**WATTS BAR NUCLEAR PLANT (WBN) – DAM SAFETY INSPECTION RESULTS AND
FUTURE SCHEDULING**

**Dam Safety Inspection Report - Class A
Watts Bar Hydro Plant
Special, Nuclear Yard Drainage Holding Pond**

File Number: 91-00
EDMS Number: J22 080807 001
UNID: WBH-00-INSP-333 -DAM
Report ID: R00WBHCLA082008

Figure 7:
View of concrete spillway slab on
downstream slope.

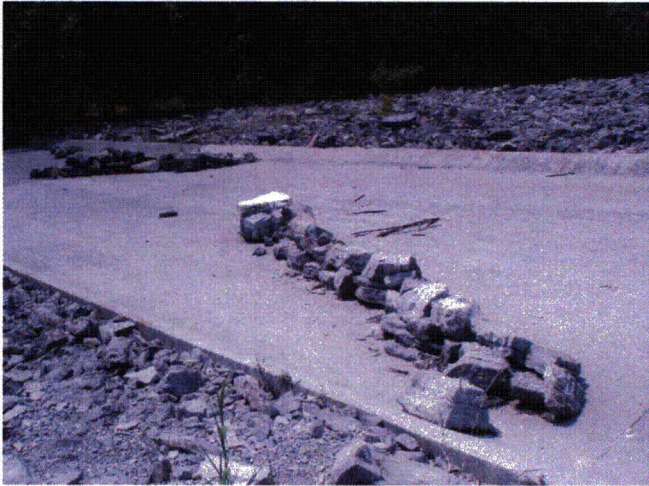
Figure 6:
View of downstream slope of dam, with concrete spillway slab. Note trees located along the toe which will require removal.

1. PM – Remove the trees located on the upstream and downstream side of the small embankment dam and spillway. Include all trees within 20' of the toe and groin areas.
Responsible Organization: Facilities Maintenance, Darrel Reed
Estimated Cost: \$4,000.00
Estimated Completion Date: 3/30/09

Figure 8:
View of a small hole that has undermined the
concrete spillway slab.

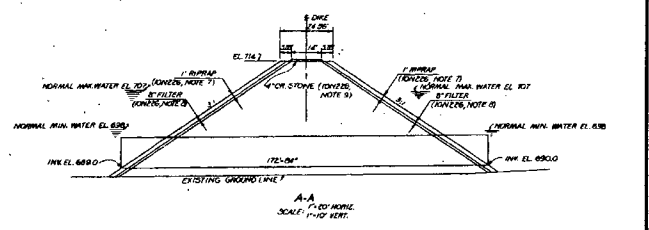
The spillway section is in satisfactory condition. A small undermined area is located on the left side of the spillway slab, which allows water to flow underneath the slab. This hole should be filled with small 1/2" stone. See Exhibit 1 for recommendations.

2. PM – Fill the small hole that is undermining the left side of the spillway slab just downstream from the crest of the dam with small 1/2" washed stone.
Responsible Organization: Facilities Maintenance, Darrel Reed
Estimated Cost: \$500.00
Estimated Completion Date: 3/30/09
